UNITED STATES
NUCLEAR REGULATORY COMMISSION
WASHINGTON, D. C. 20555

BYRON STATION, UNIT 1

AMENDMENT TO FACILITY OPERATING LICENSE

ATTACHMENT TO LICENSE AMENDMENT NOS. 21 AND 21
FACILITY OPERATING LICENSE NOS. NPF-37 AND NPF-66
DOCKET NOS. STN-50-454 AND STN 50-455

FIGURE 3.4-4

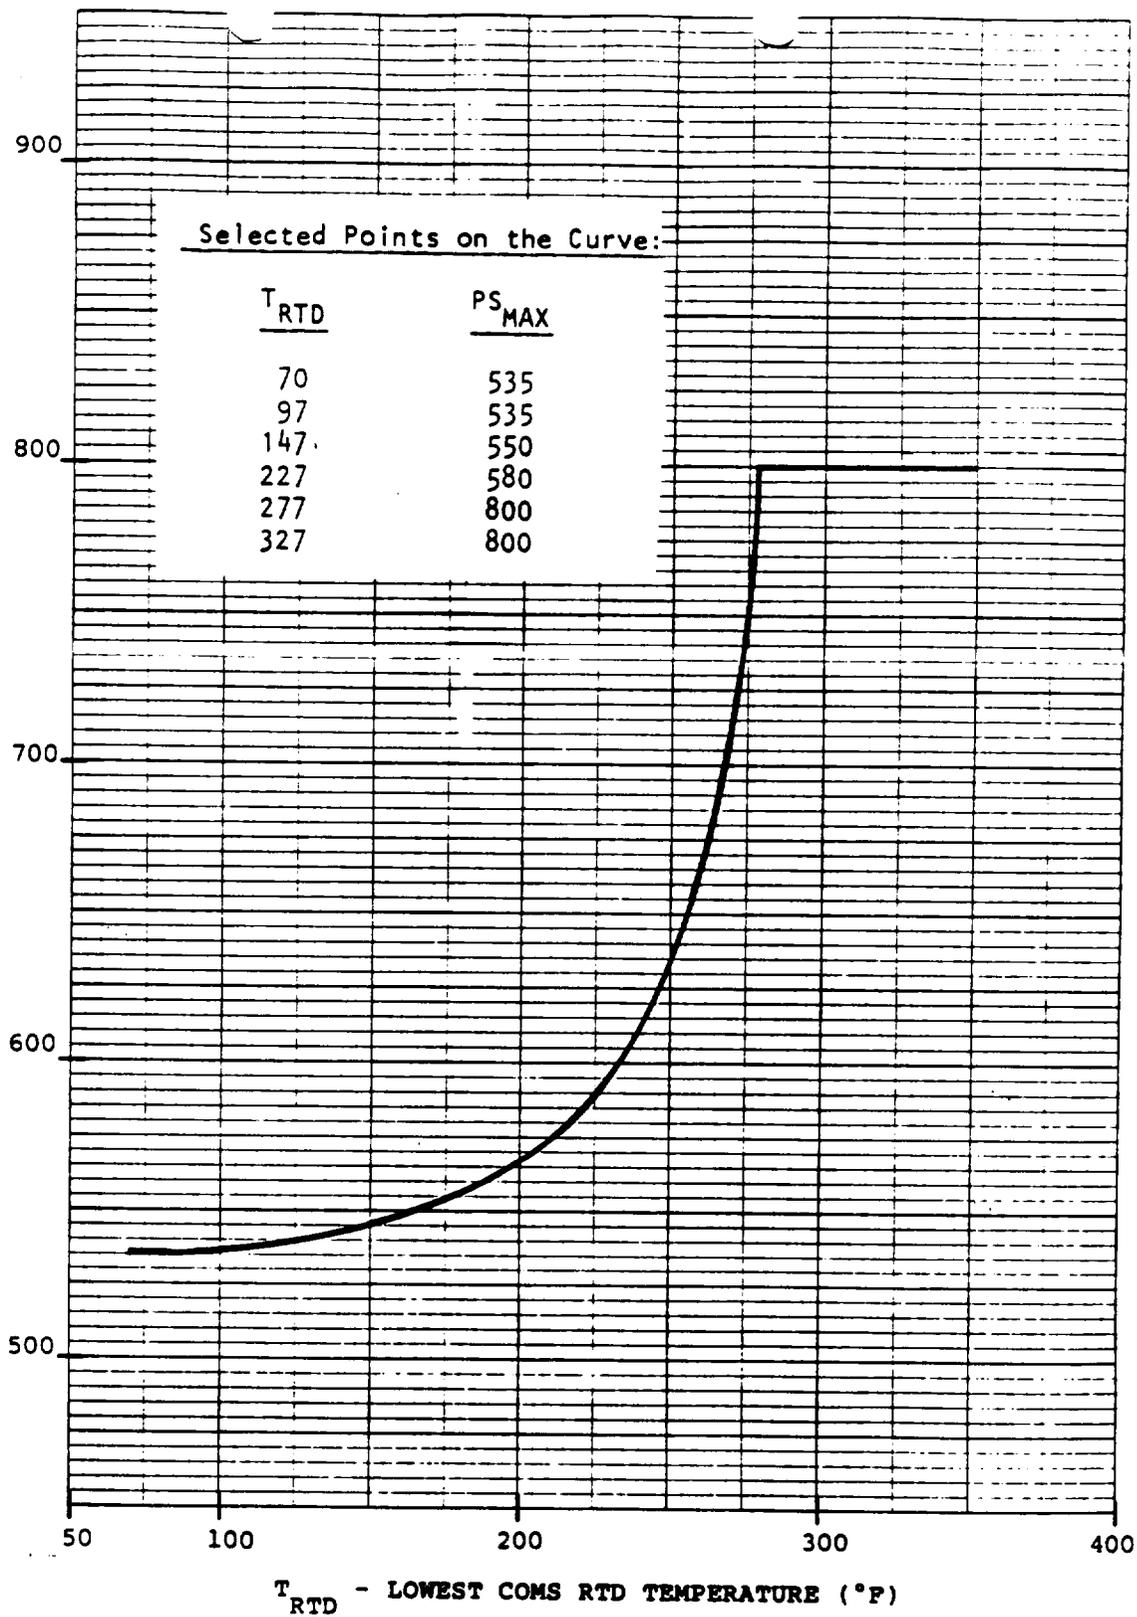
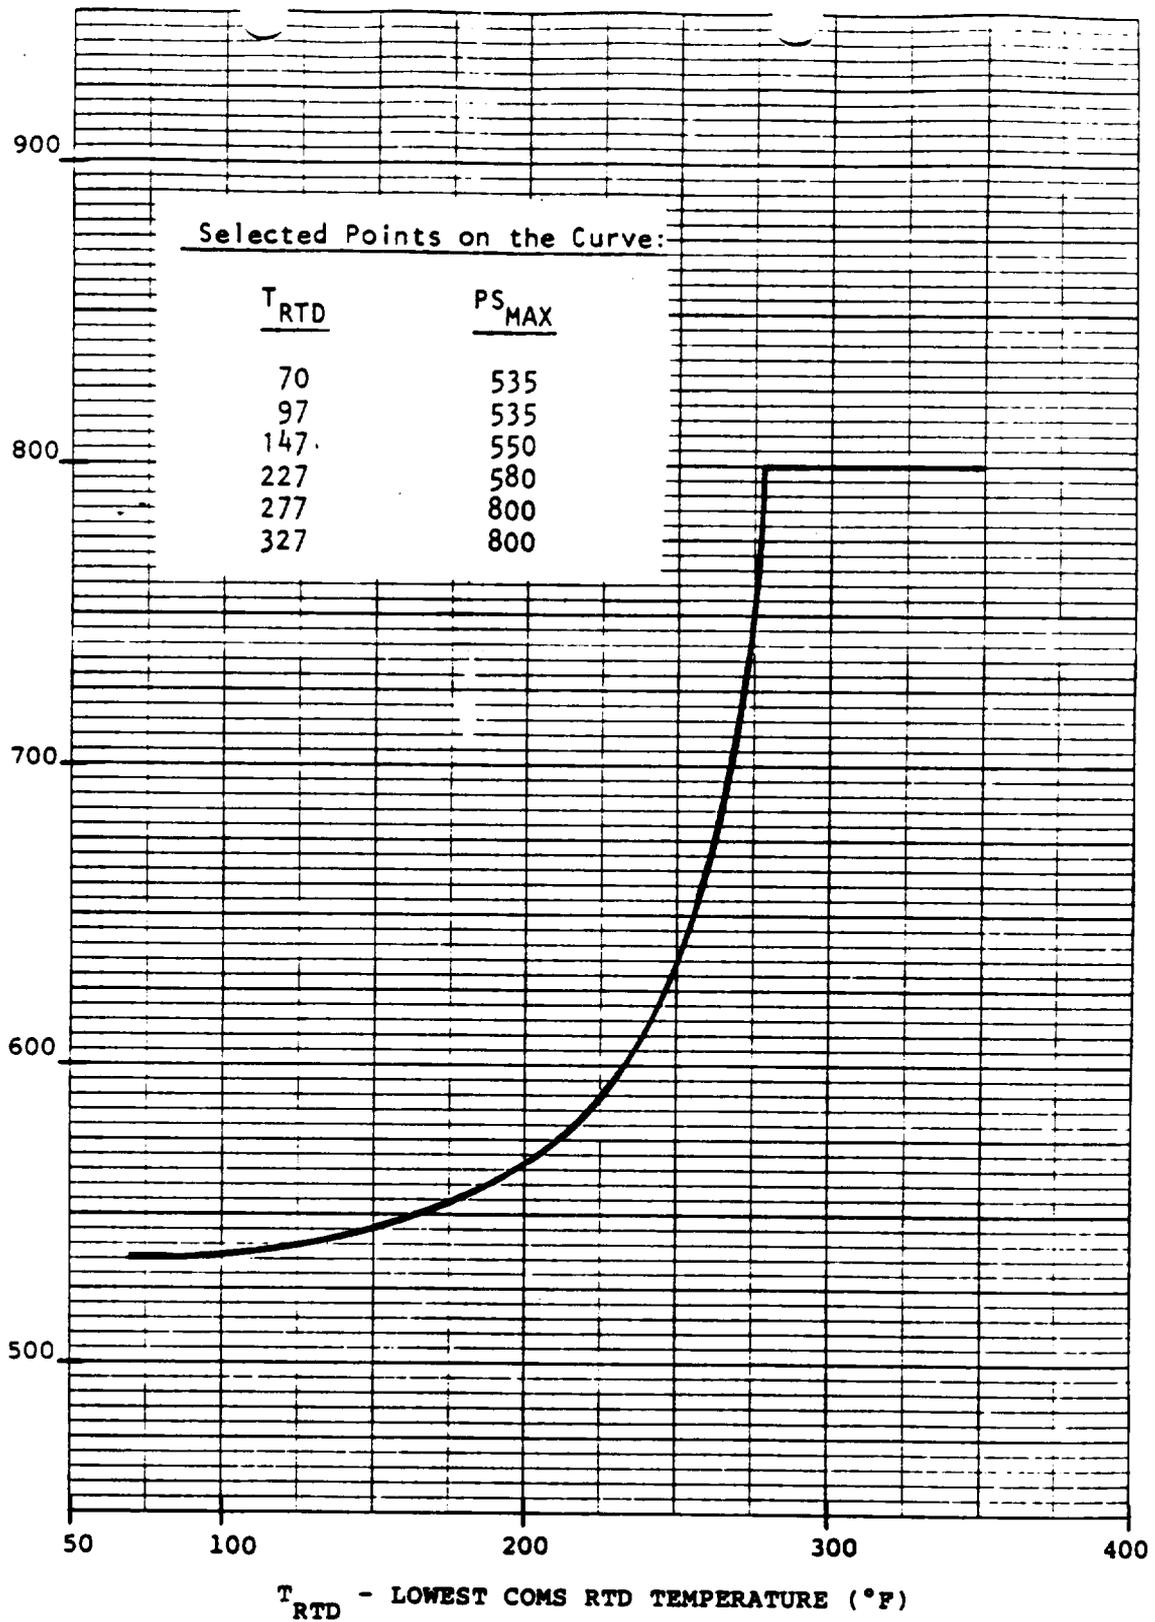
The proposed change revises Figure 3.4-4, "Nominal PORV Pressure Relief Setpoint Versus RCS Temperature for the Cold Overpressure Protection System Applicable up to 10 EFPY." The changes reflect a larger uncertainty in the wide range temperature instrumentation and prevent the need for additional stress analyses following an overpressure event.

The requested change to Cold Overpressure Mitigation System (COMS) setpoints is based on a letter from Westinghouse dated November 18, 1985 for two reasons: (1) A larger uncertainty in the wide range temperature instrumentation is assumed; and (2) The updated COMS setpoints eliminate the need for a detailed stress evaluation of the PORV inlet and discharge piping and steam generator tube sheet following a single overpressure event. The revised setpoints meet 10 CFR Part 50, Appendix G criteria and are consistent with the Byron/Braidwood FSAR. The margin of safety has not been reduced because the change is in the conservative direction and is therefore bounded by previous analyses. The proposed change is considered acceptable.
